Sub: 82वीं संरक्षण समन्वय उप-समिति (पीसीसी) बैठक का कार्यवृत्त/ Minutes of 82nd Protection Coordination Sub-Committee (PCC) Meeting

82nd Protection Coordination Sub-Committee Meeting

Date: 21/08/2025 (Thursday)

Event 1: Grid disturbance in Chiephobozou, Wokha and Sanis areas of Nagaland Power System on 1st July'25

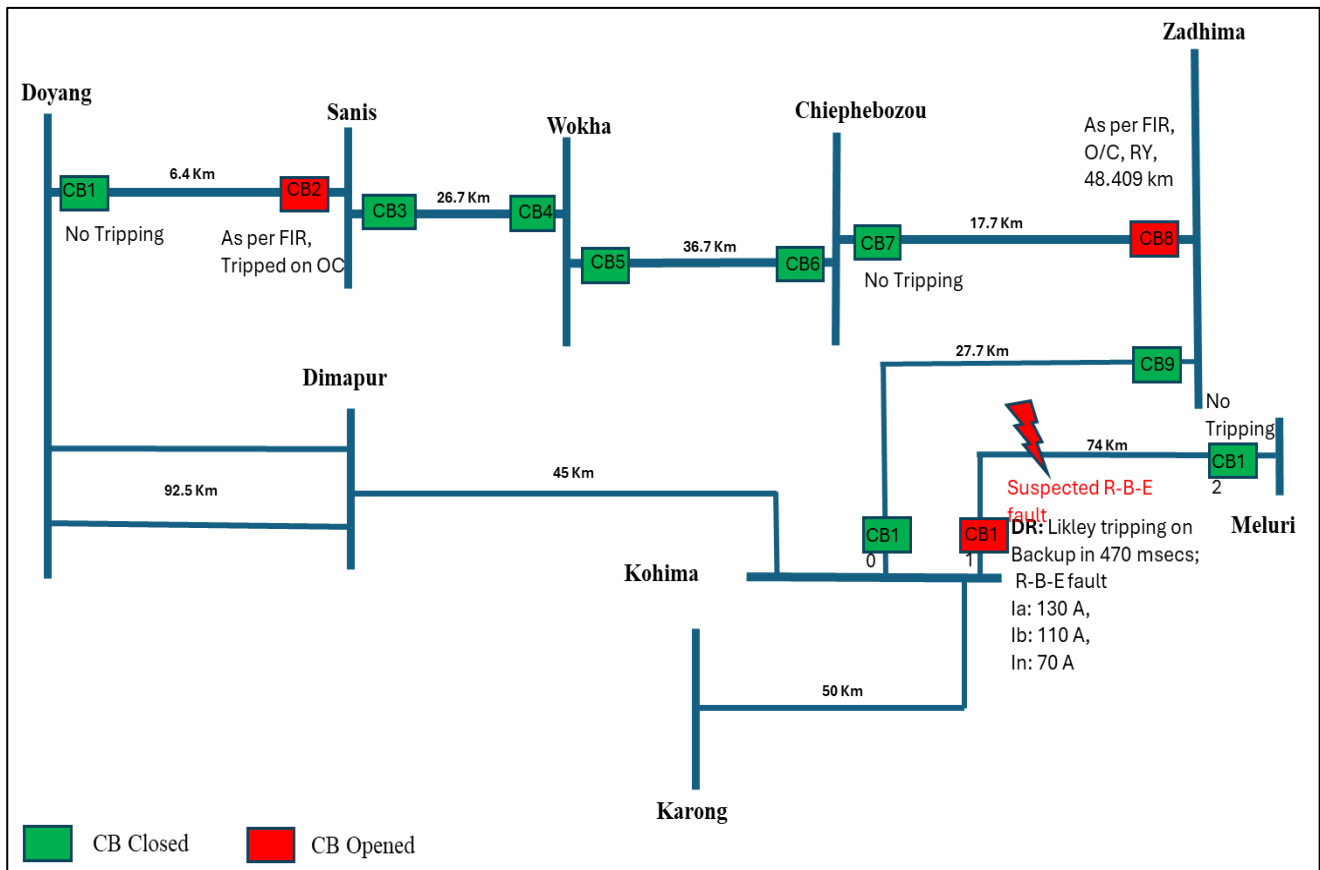
- Suspected fault was in 132 kV Kohima-Meluri line, R-Y-N fault (Ir-130 A, Iy-110 A, In-70 A) initiated at 15:31:18.759 Hrs which has cleared within 470 msec from Kohima end likely on operation of backup protection.
- Tripping of 132 kV Zadhima-Chiephebozou line on O/C from Zadhima end for fault beyond the line seems unwanted.
- Tripping of 132 kV Doyang-Sanis line on O/C from Sanis end for fault beyond the line seems unwanted.
- Backup protection setting at Doyang & Zadhima end needs to be reviewed along with its directionality.
- DR/EL file of CB8 not opening.
- Non-submission of DR/EL file for CB2 which is a violation of Clause 37.2 (c) IEGC-23.

NERLDC highlighted that there were directionality issues with Back up protection at Sanis and Zadima. DoP Nagaland updated that the directionality issues have been rectified. Further NERLDC informed that no DR has been received from Zadima for the incident and requested DoP Nagaland to provide the same at the earliest.

Event 2: Grid disturbance in Kohima, Meluri, Zadhima, Chiephobozou, Wokha and Sanis areas of Nagaland Power System on 10th July'25

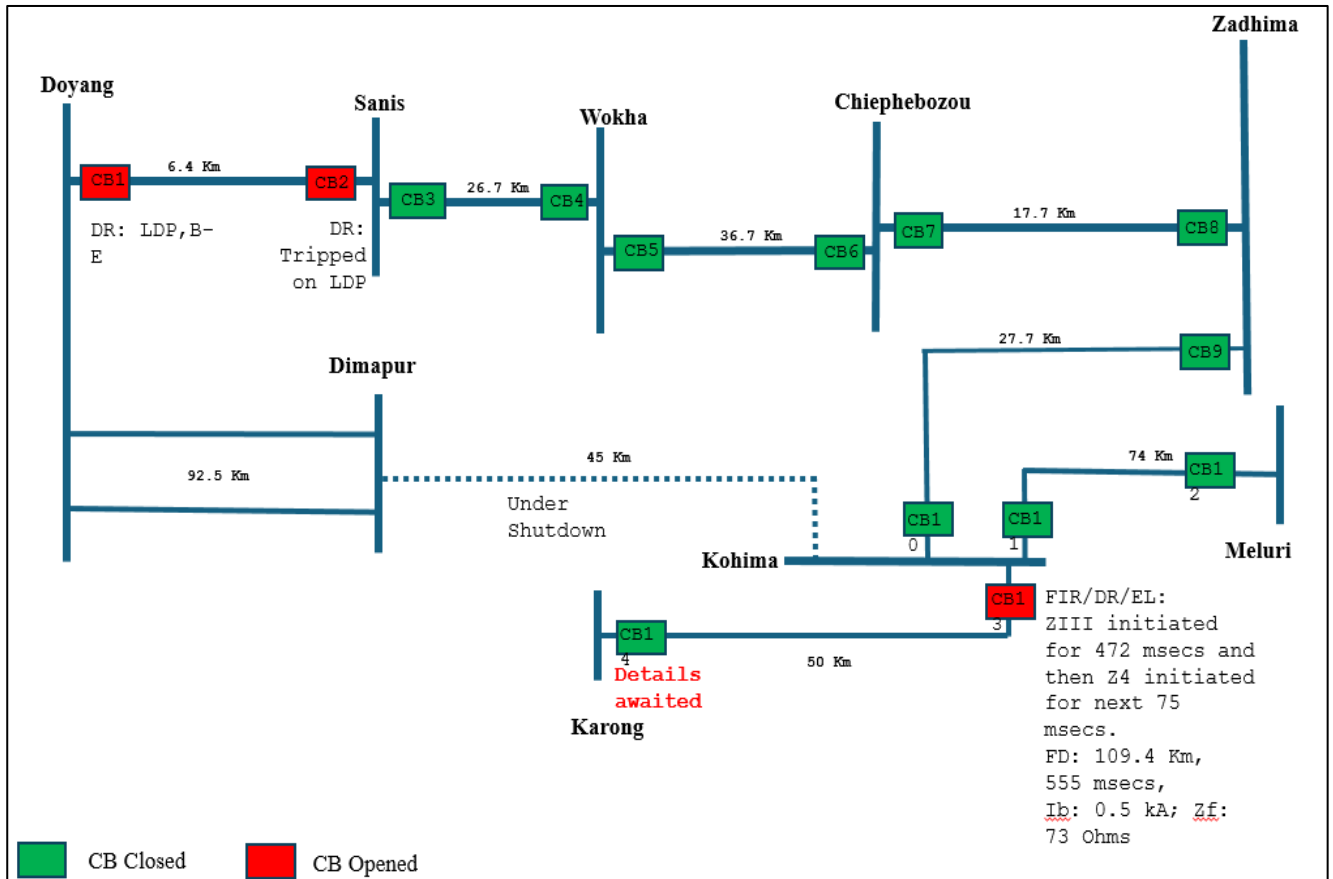
- At Kohima end, Main relay detected the B-E fault in ZIII for 480 msec & after that Z4 picked up for 70 msec. Also, In>1 start observed for 550 msec. Fault cleared at Kohima in 555 msec with Ib as 0.5 kA. However, FD of 109.4 KM need to be reviewed.
- Likely high resistive (L-G) fault in the system likely in downstream of Karong.
- 132 kV Doyang-Sanis Line tripped on operation of LDP from both ends within 171 msec which seems to have maloperated.

Event 3: Grid Disturbance in Zhadima, Chiephobozou, Wokha and Sanis areas of Nagaland on 11th July'25

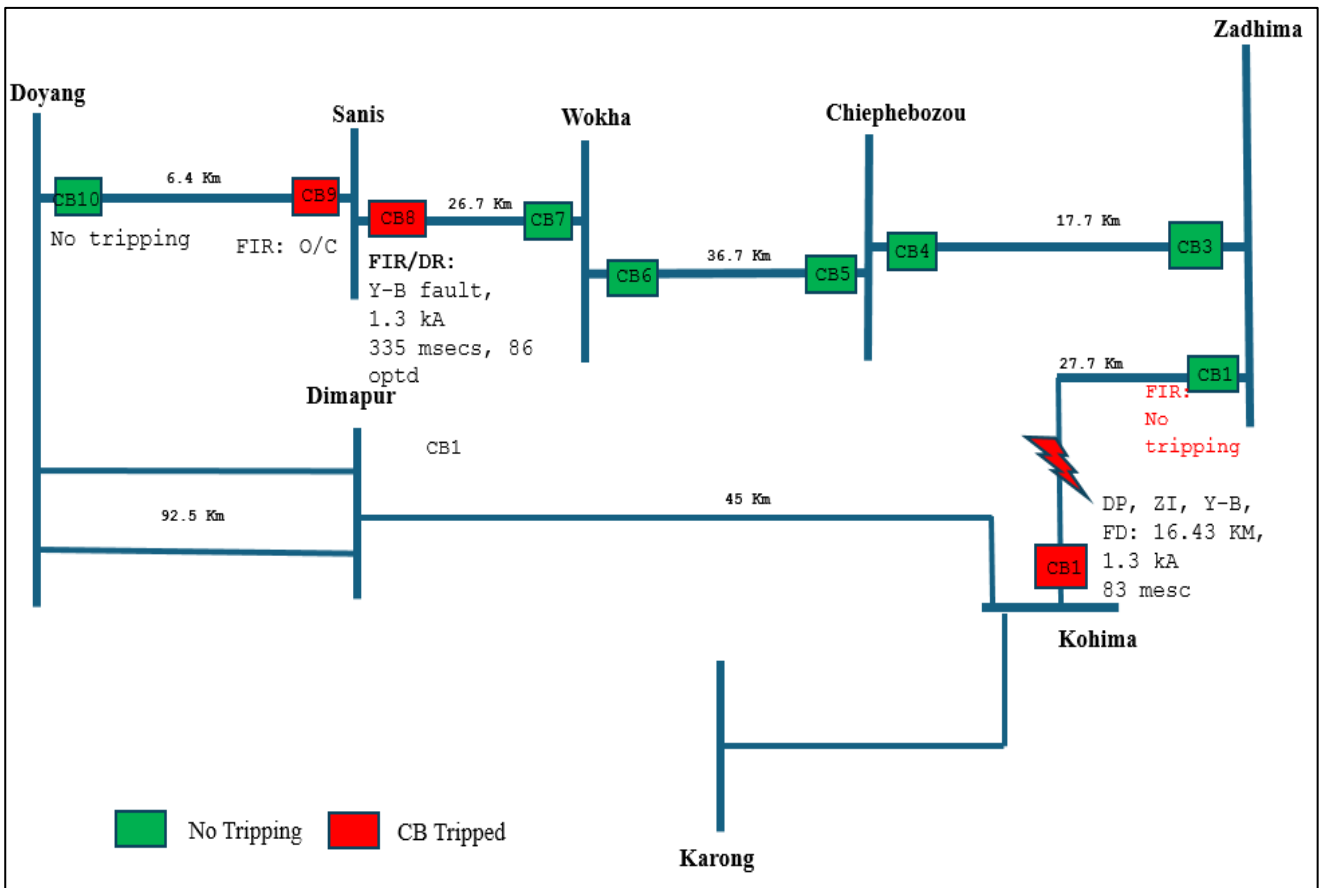
Y-B fault in 132 kV Kohima – Zadhima line cleared on tripping from Kohima end in DP, ZI. But no tripping observed at Zadhima. Same fault cleared by the relay at Sanis end of 132 kV Sanis-Wokha line on suspected operation of OC protection within 335 msec.

Event 4: Grid Disturbance in Kohima, Sanis, Wokha, Chiephobozou and Zhadima areas & Likimro HEP of Nagaland on 26th July'25

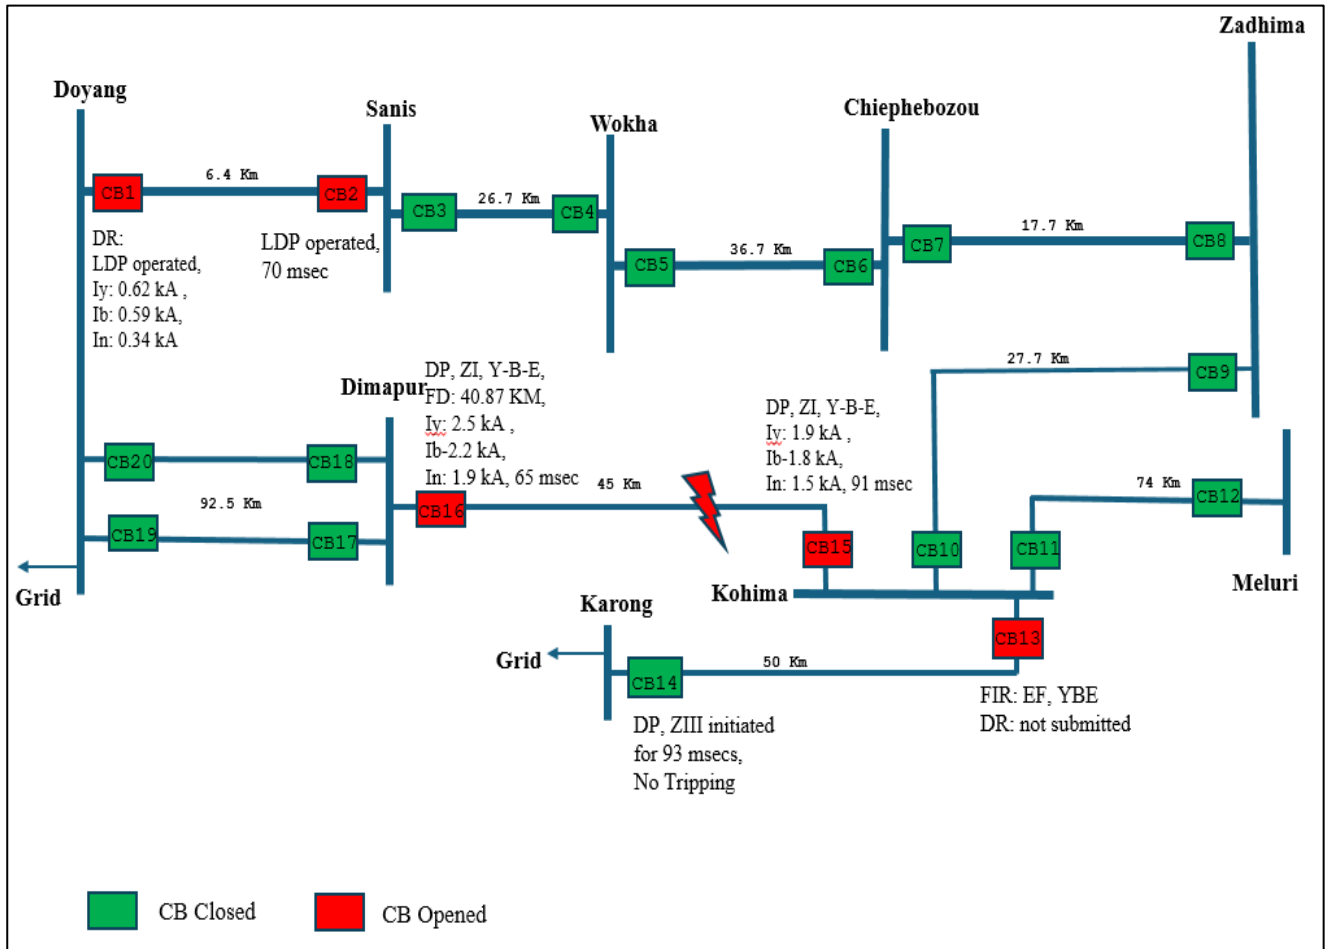
As per DR analysis, Y-B-N fault (I_y -2.5 kA, I_b -2.5 kA, I_n -2 kA) in 132 kV Dimapur-Kohima Line initiated at 14:08:20.039 Hrs which was cleared within 65 msec from Dimapur end and within 91 msec from Kohima end on operation of DP, ZI.

B.7 Grid Disturbance in grid event in Khupi, Tenga, Seppa and Dikshi HEP area of Arunachal Pradesh Power System on 4th July'25:

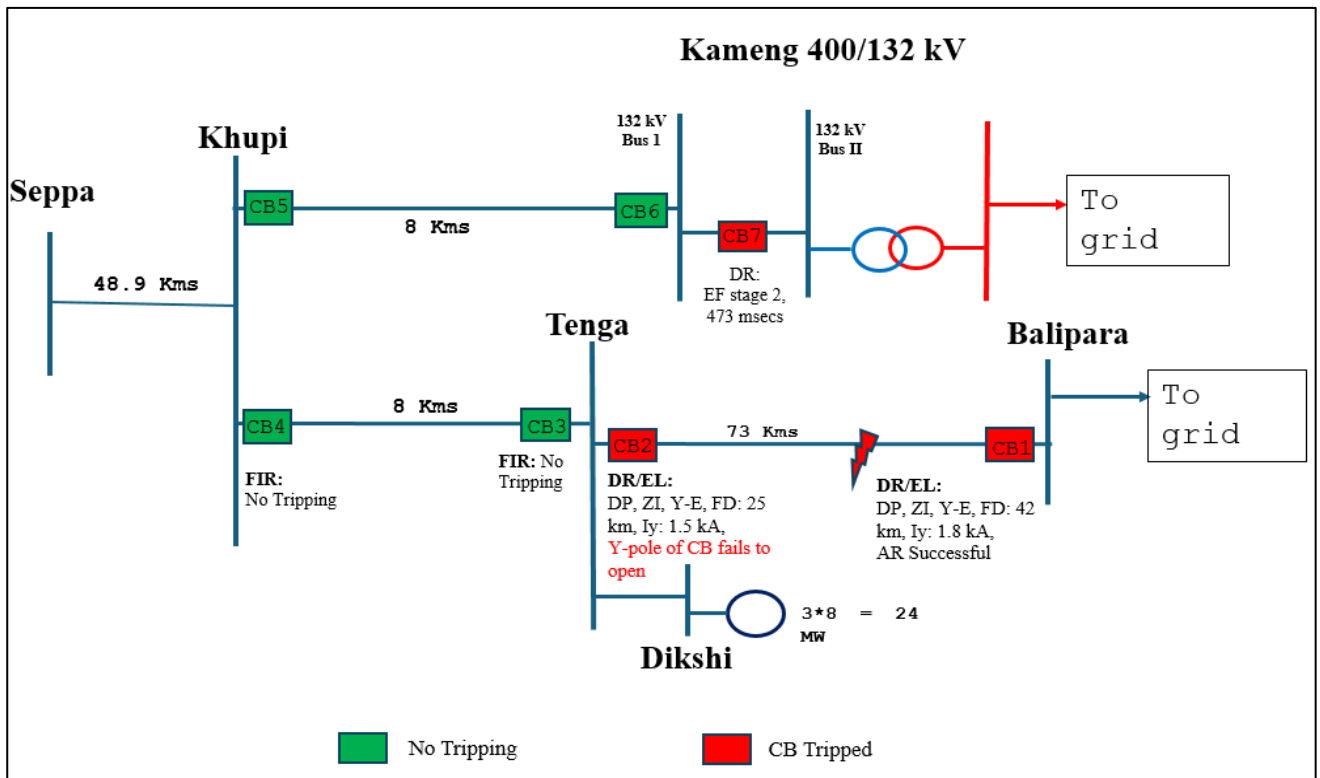
As per DR analysis, Y-N metallic fault initiated in 132 kV Balipara – Tenga line cleared from Balipara end in DP, ZI, Y-E, FD: 42 KM, Iy/Ib: 1.8 kA/1.4 kA, in 55 msec & AR successful from Balipara end after 1.5 seconds. Tenga end detected the fault in DP, ZI, Y-E, FD: 25.37 KM, Iy/In: 1.4 kA/1.8 kA, however Y-phase current continued to flow, implying incomplete interruption on that pole and leaving the fault electrically energised from the Kameng side via the 132 kV Tenga-Khupi-Kameng interconnection. The Khupi end B/U relay sensed the persisting fault ($I > I_N$ Start), while the 132 kV Bus Coupler at Kameng tripped on EF ($I_N > I$) in 473 msec.

B.9 Grid Disturbance in Tipaimukh area of Manipur Power System on 13th July'25:

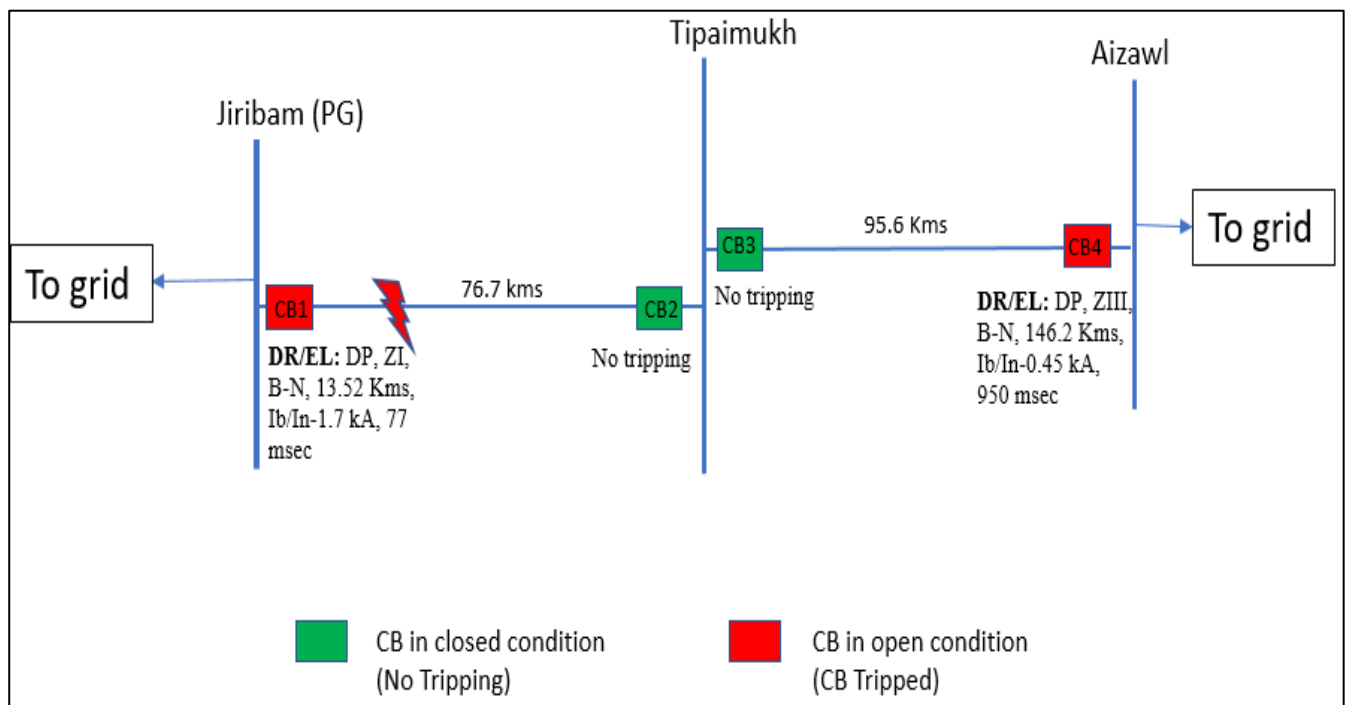
As per DR analysis, high resistive B-N fault (Ib-1.7 kA, In-1.7 kA) in 132 kV Jiribam-Tipaimukh line initiated at 12:02:14.224 Hrs which was cleared within 77 msec from Jiribam end on operation of DP, ZI. DR/EL of Tipaimukh end not submitted.

MSPCL to update the action taken on the above mentioned issues.

MSPCL informed that fault was not cleared at Tipiamukh end as the relay did not pick up at the substation. To ascertain the root, cause an external is required to access the substation due to prevailing law and order situation therein, further they informed that NERPSIP has been asked to visit the substation.

Forum requested MSPCL to rectify the issue at Tipaimukh at the earliest.

B.11 Grid Disturbance in Daporijo, Basar & Along areas of Arunachal Pradesh Power System on 27th July'25:

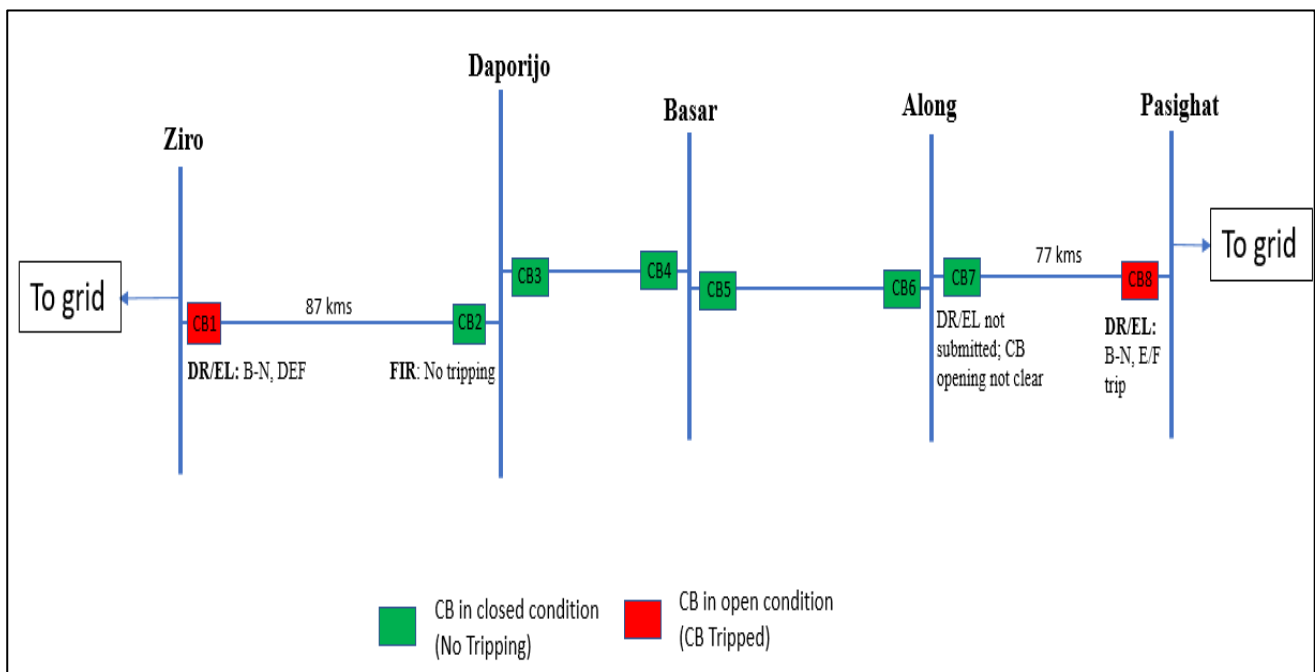
As per DR analysis of 132 kV Along-Pasighat line at Pasighat end, high resistive B-N fault initiated at 04:57:47.362 hrs with Ib-59A, In-111 A, Vbn-74 kV. At 04:57:50.844 Hrs, IN>2 trip observed. Total Fault duration: 3.55 sec. 132 kV Ziro-

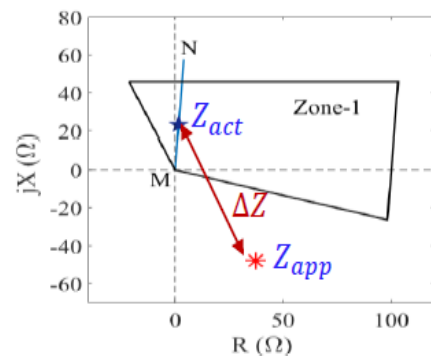
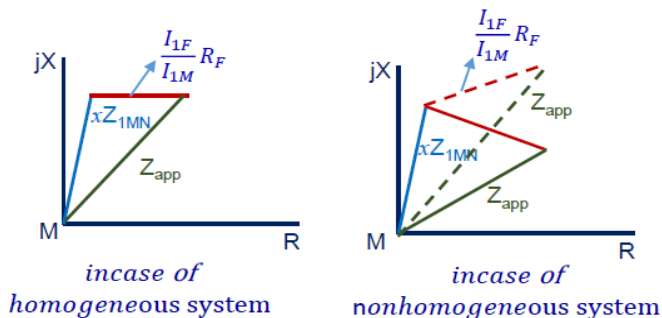
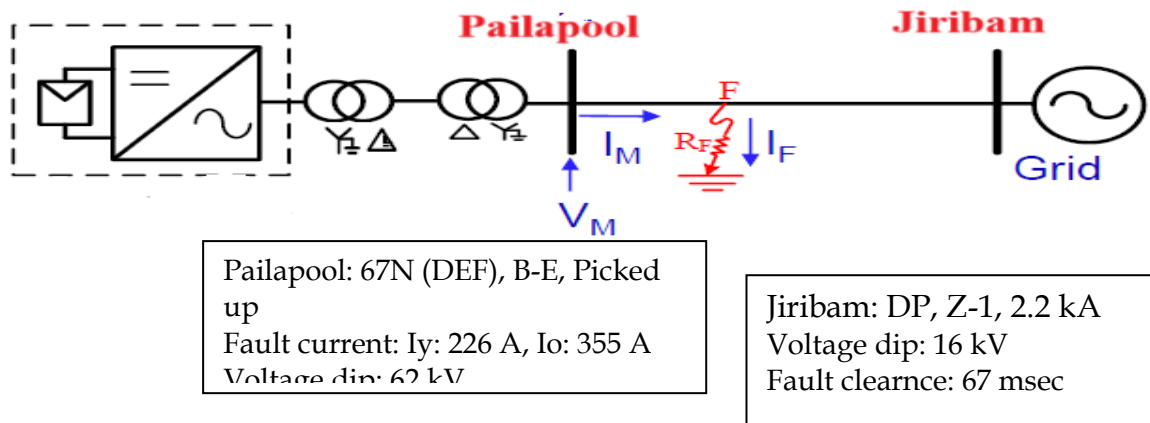
Also, due to non-homogeneity issue mal-operation of distance relay will be reported more in case of line connecting solar plant in the near future due to more IBR integration in NER Grid. Also, Distance Relay characteristics shown below as well as Fault impedance equation, it is observed that impedance locus is not encroaching to quadrilateral characteristics due to large shift of ΔZ from horizontal axis due to Non-homogeneity issue.

- This event pertains to a fault on a transmission line that is radially connected to a PV plant. In the case of an Inverter-Based Resource (IBR), the fault current is inherently limited due to the inverter's current-controlled nature. Furthermore, the voltage-current (V-I) characteristics during fault conditions are modulated differently compared to conventional synchronous grid sources, resulting in non-homogeneity in the system response.
- Given the anticipated increase in IBR integration within the NER Grid in the near future, it is expected that similar protection-related challenges will arise more frequently.
- Zero-crossing DC offset was observed following the tripping of the breaker at the Remote Jiribam (PG) end.
- Low fault current contribution was observed, which imposes limitations on conventional protection schemes.
